# TOWN OF ELLINGTON

## ELLINGTON INLAND WETLANDS AGENCY REGULAR MEETING AGENDA MONDAY, JULY 13, 2020 7:00 P.M.

1. IW202004 – MJS Leasing LLC & Chilson Realty Co., owners/ Town of Vernon & Town of Ellington, applicants request for a map amendment and permit to conduct regulated activity for the construction of four full-size soccer fields, parking and access roads, concession and restroom buildings, and associated site improvements on properties along the east side of Windermere Ave near the Vernon town line, at APNs 011-033-0000, 019-005-0004 and 019-005-0005. **(Continued from June 8, 2020 meeting)**
2. IW202005 – Daniel Houlihan, owner/applicant request for a map amendment at 42 Crane Road, APN 068-002-0000. **(Notice requirements met, hearing may commence)**

John, David and I have been discussing some of my preliminary comments on the original plans. These latest plans are a product of that initial discussion. While we are moving in the right direction, there remain a few items to be addressed and some additional items I did not identify in my initial discussions with David. I offer the following wetland comments for consideration prior to Monday's wetland meeting:

**SITE PLAN FIELD - 1**

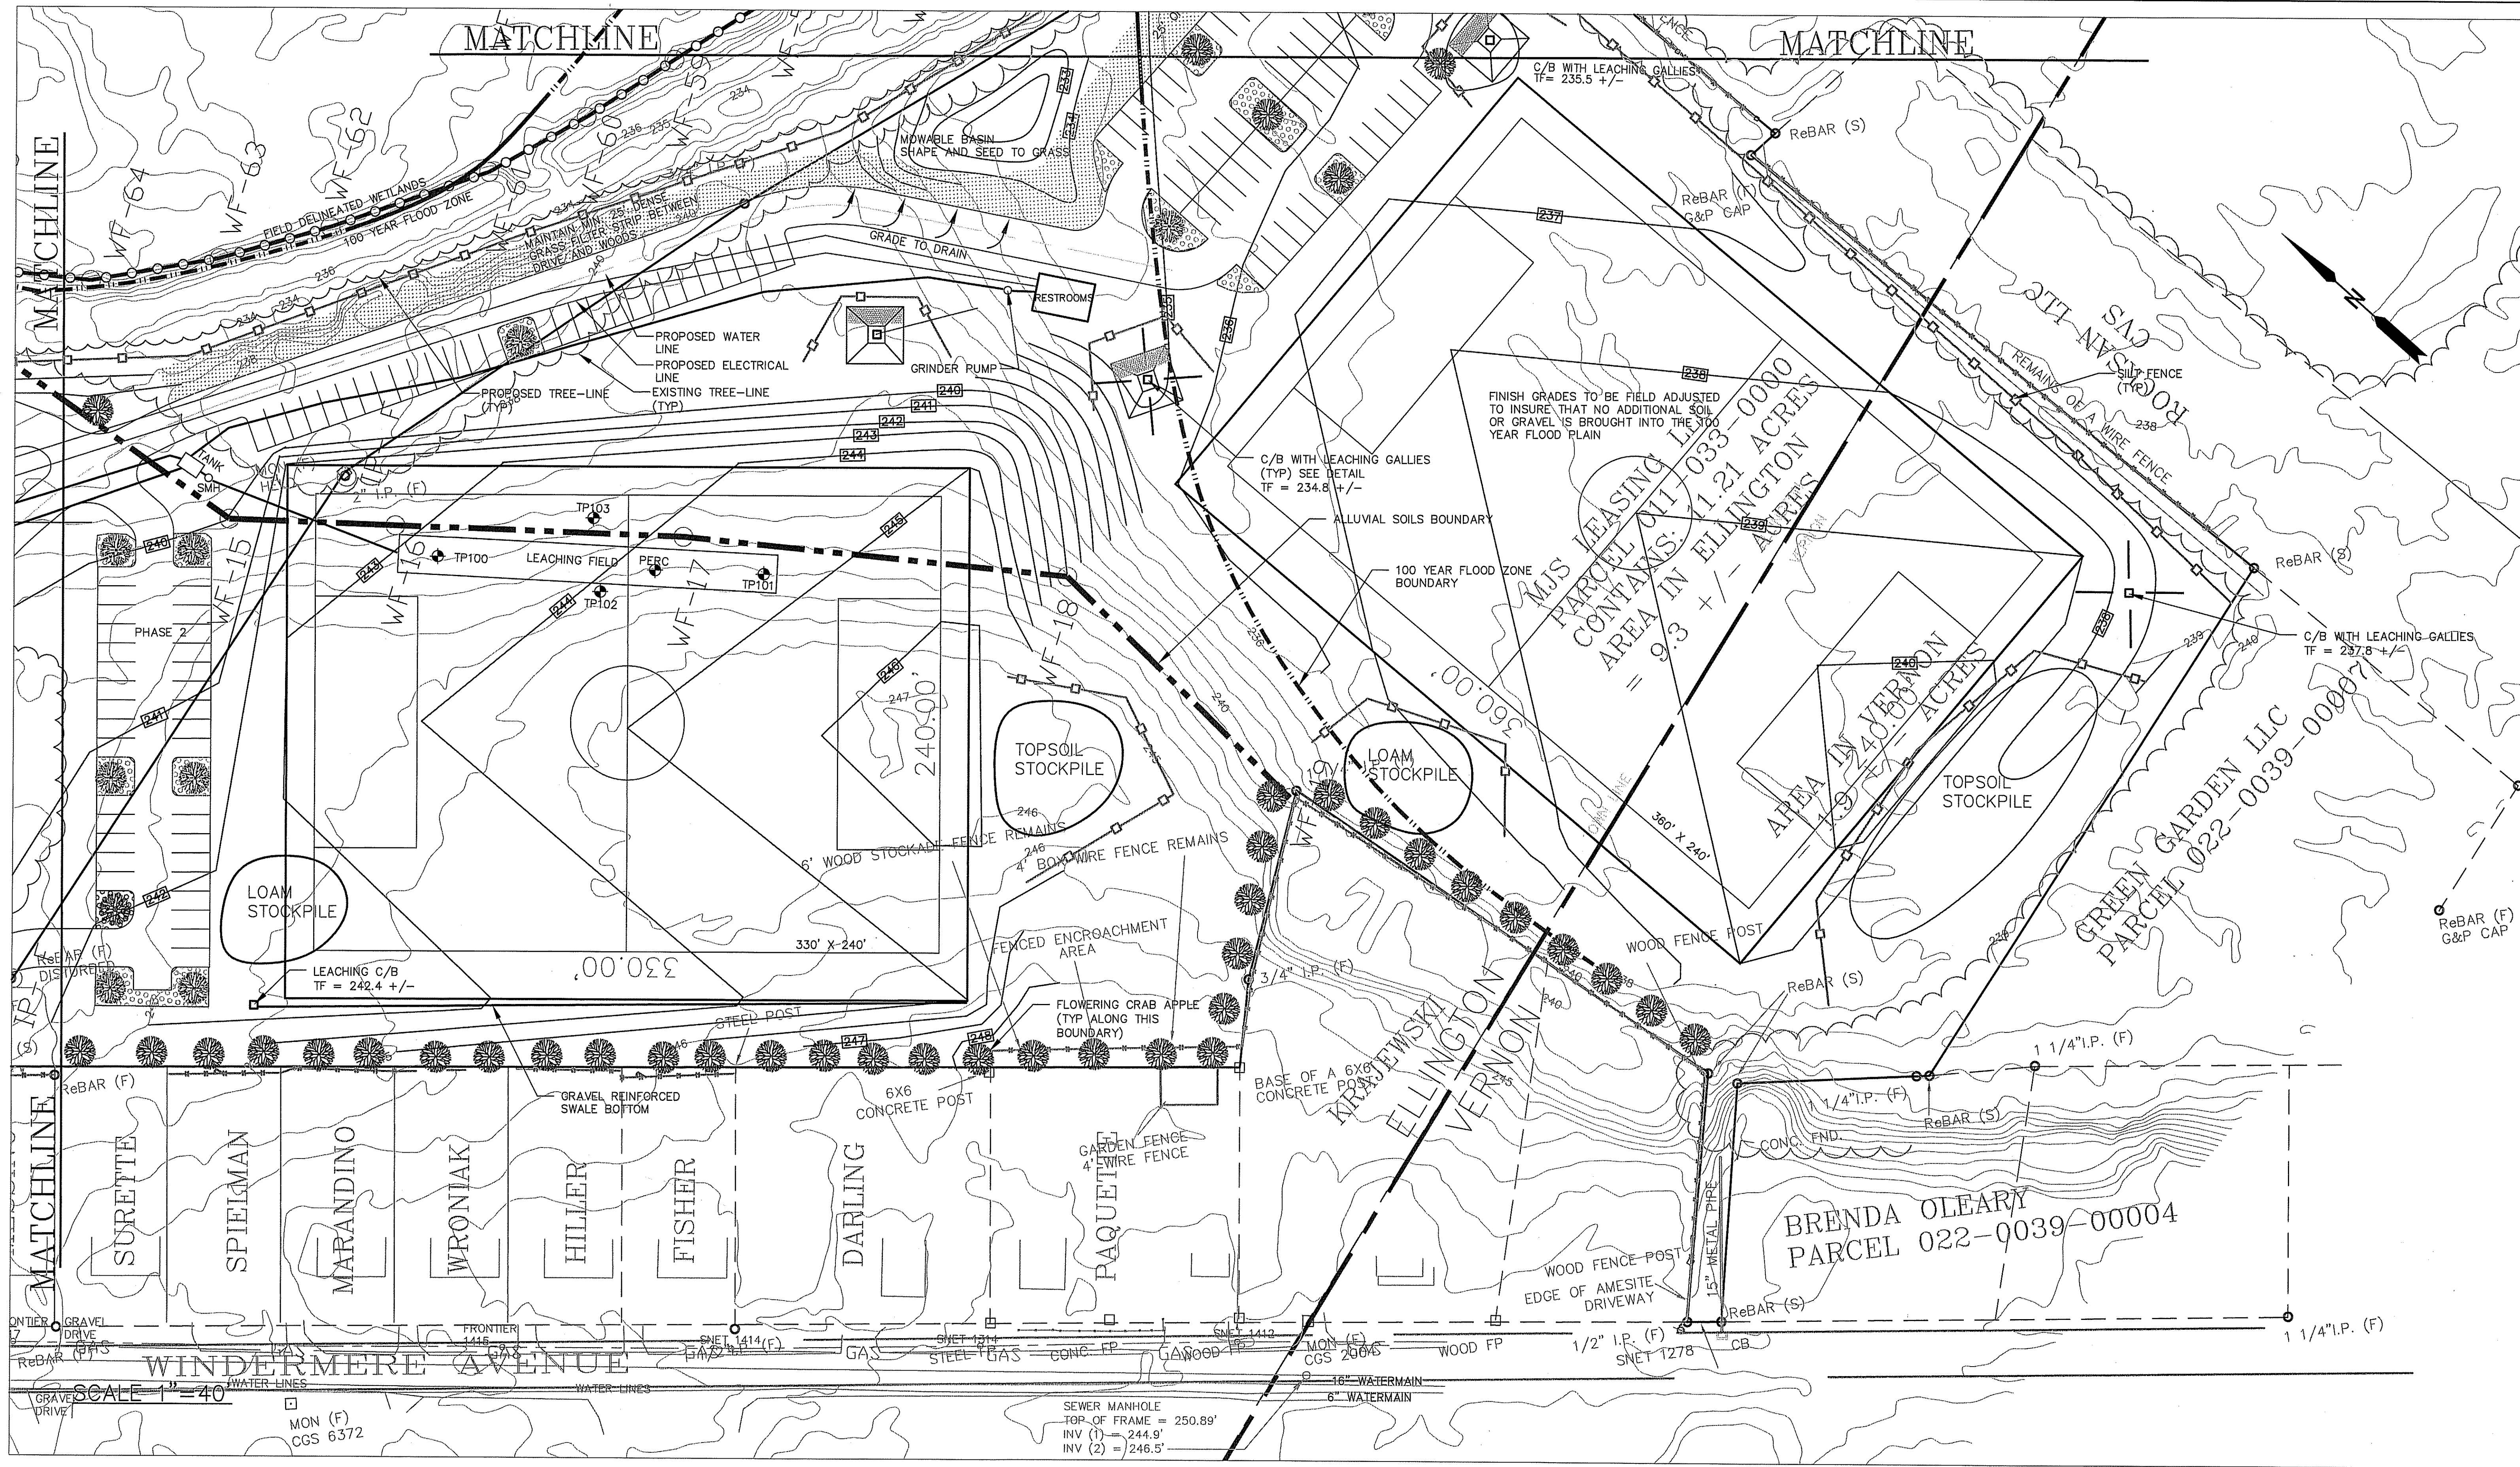
1. The drawing is difficult to read as all the line types are the same. Provide different line types, legend and more labels to distinguish between utility lines, existing contours and proposed contours. It appears that the proposed 238 and 239 contours are missing on sheet 4.

2. Limits of disturbance are not clearly defined other than by silt fence location. A proposed tree clearing limit should be indicated on sheet 4 beyond the perimeter silt fence where encroaching into existing vegetation.

- The line work has been much improved to increase the drawing's readability. We have also provided an additional "Boundary" sheet to help identify the actual project limits. The 'balloons' showing the limits of each phase have been eliminate to reduce the busy-ness of the drawings.

**SITE PLAN FIELD - 2 & 3**  
**WINDERMERE FIELDS**  
WINDERMERE AVENUE  
ELLINGTON & VERNON CT  
**TOWN OF VERNON**  
ENGINEERING DEPARTMENT  
14 PARK PLACE, VERNON, CT 06066  
SCALE: 1" = 40' DATE: MAY 4, 2020 SHEET: 5 OF 8  
FILE: Q:\PARKS and REC\WINDERMERE SOCCER FIELDS

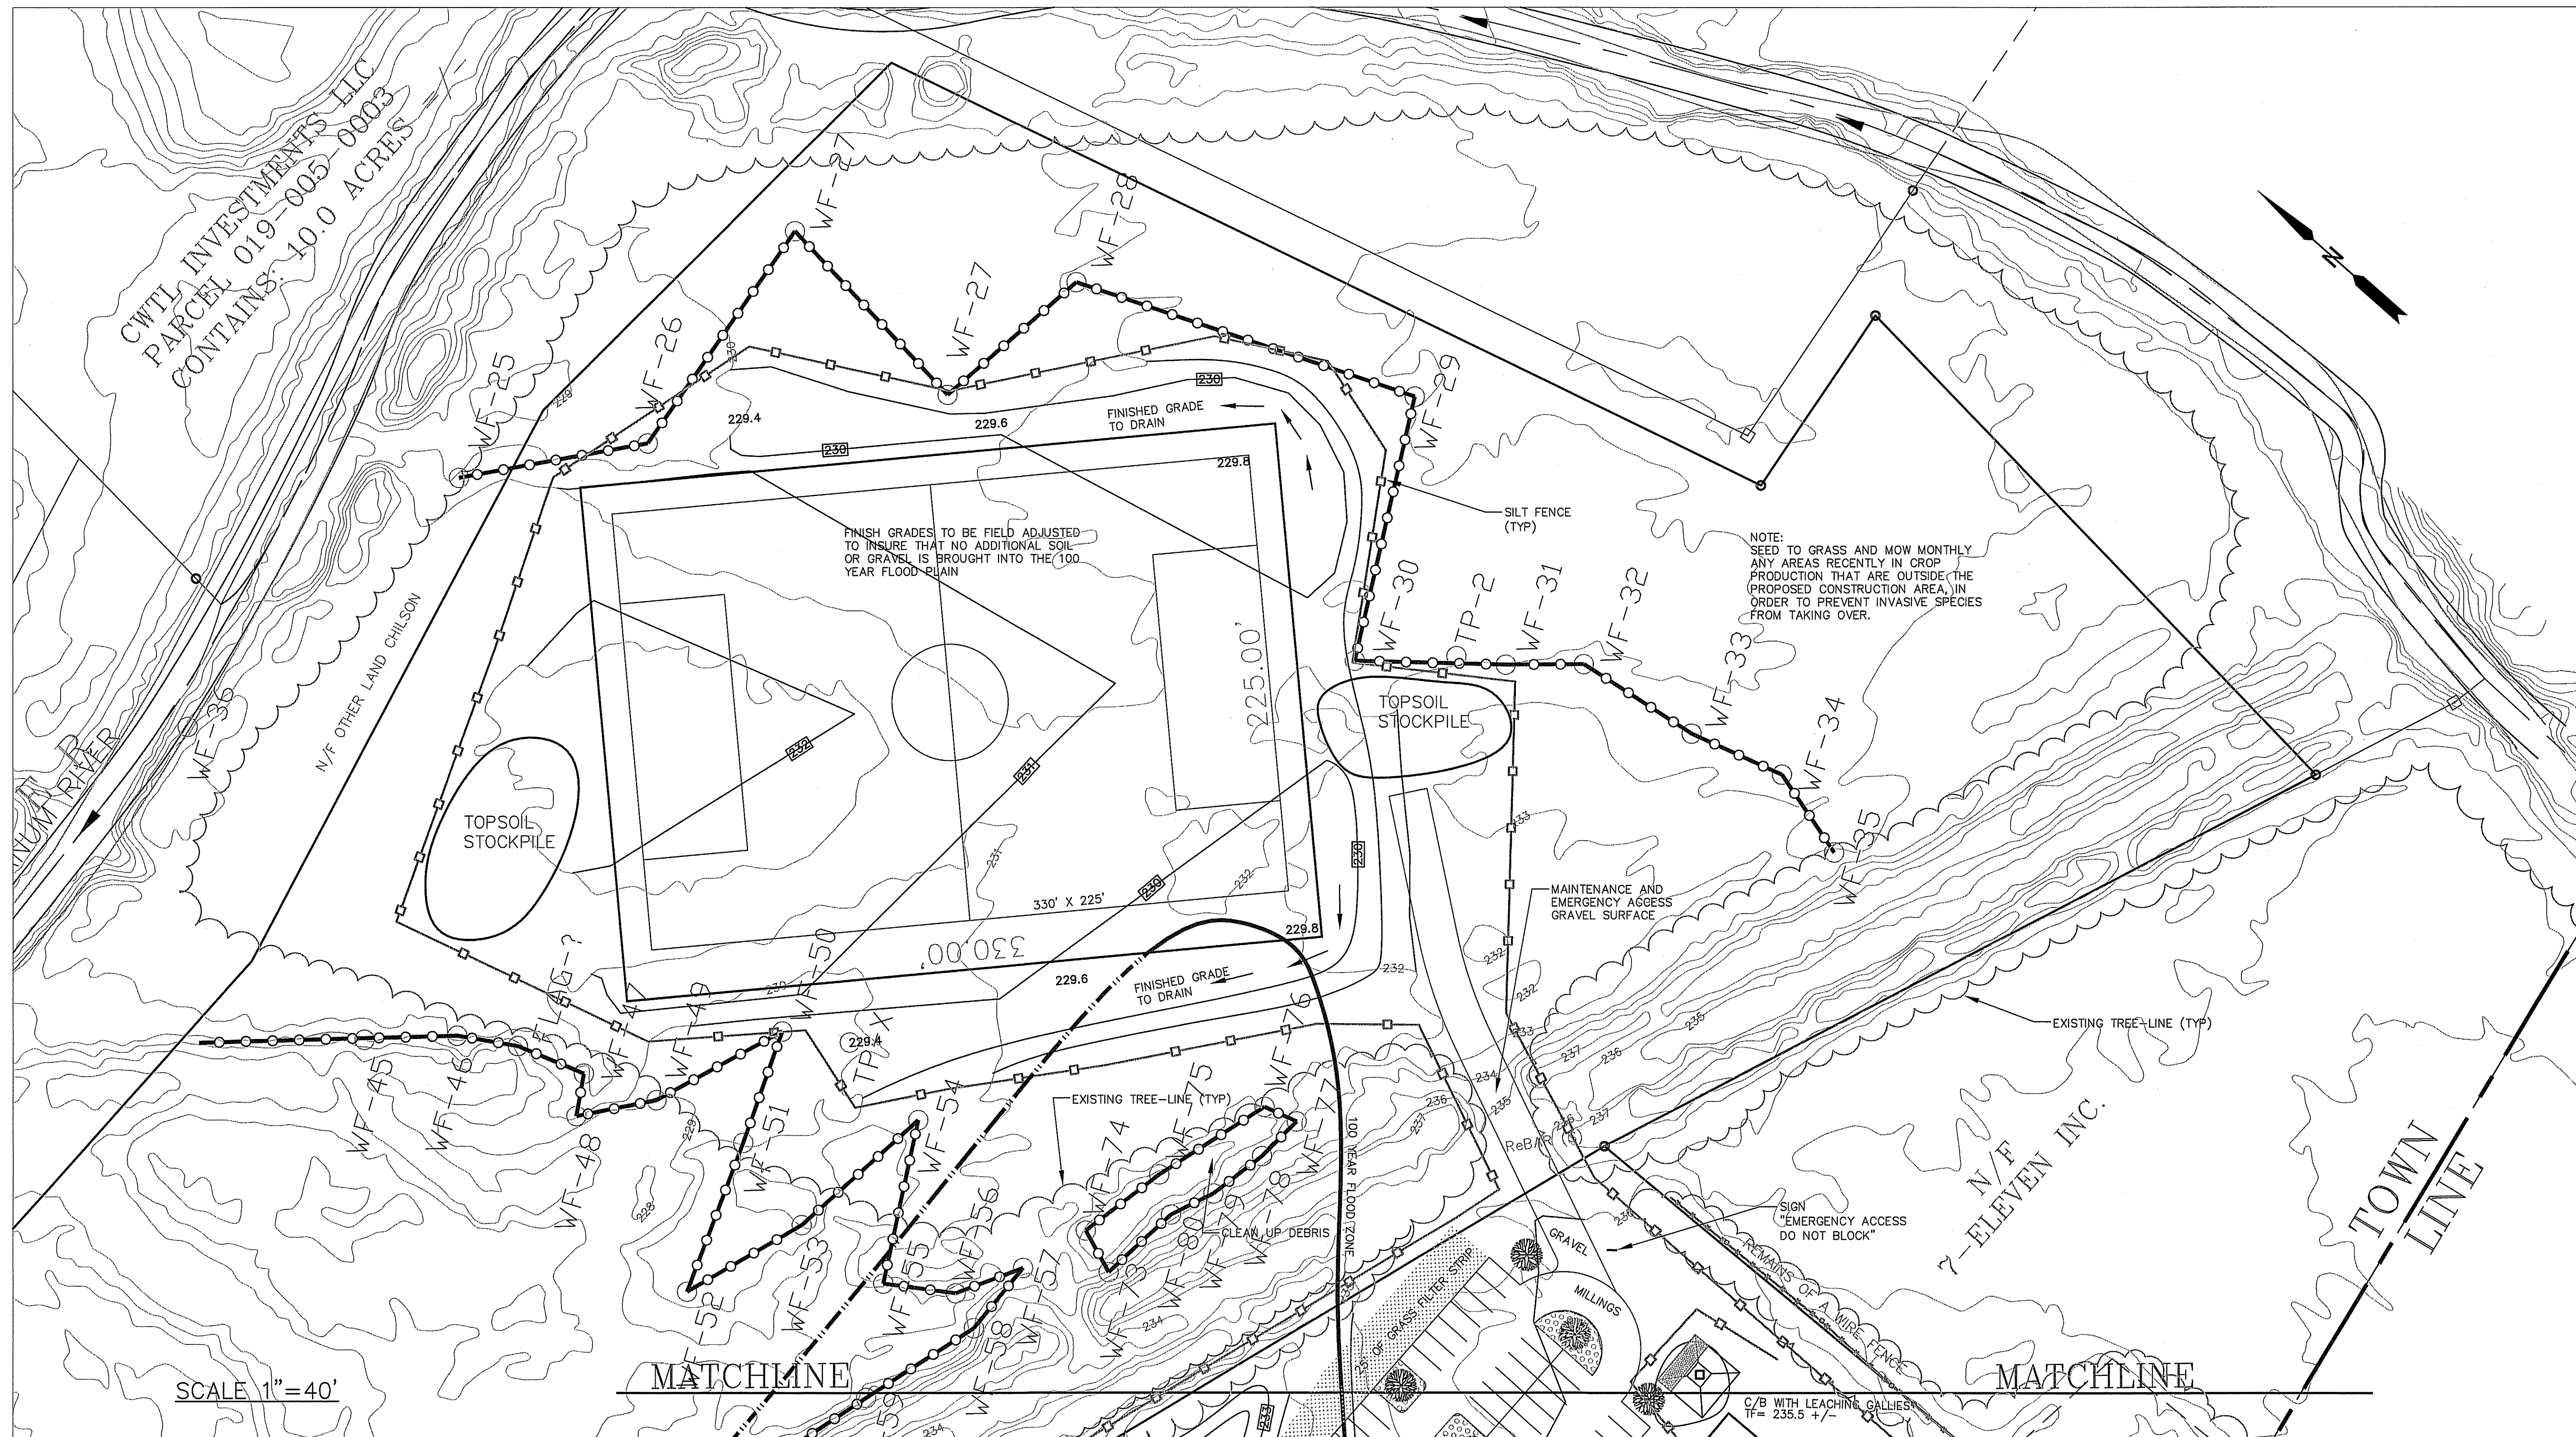
3. Field 4 includes two low spots at the southern corners of the field below contour 230. It does not appear that these areas will drain to daylight without grading beyond the silt fence limit. Provide spot grades and clarify whether these are intended to drain toward the wetlands or retain water. If they are to surface drain, move the perimeter silt fence to the daylight limit and note the area of temporary wetland disturbance if applicable.

- Field 4 as presently shown, has two low spots on the easterly end that are nearly flat. Spot elevations provided on the plan do indicate that the surface can be shaped to provide some outlet for these depressions, but they will also likely function as mowable basins shown elsewhere on the drawing. The desire to not impact poorly or very poorly drained soils and to prevent loss of flood storage limits the options available in this location. Field 4 may from time to time not be available for play, but I believe that the underlaying well drained soils will rapidly dissipate any accumulation of rainwater, and reduce the frequency and duration of this inconvenience.
